Service Information: **Range adaptation**

Corteco No **01002369B**

MATERIAL CHANGE DESIGN UPDATE

Figure 1: oil seal 01002369B
old design

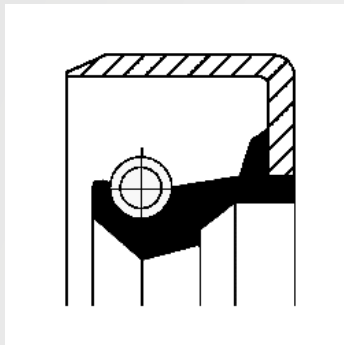
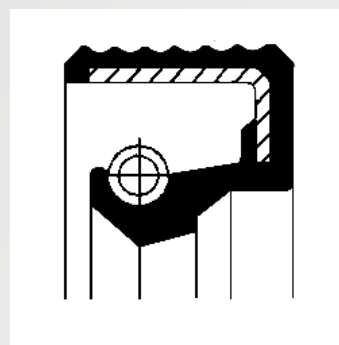
According to OEM directions our Lead Center has replaced oil seal 01002369B by Corteco n. 12010784B.

Main difference is coverage of the outer diameter: the cover of the old version was metallic while the outer surface of the new design is covered with grooved rubber. This ensures better static sealing performances.
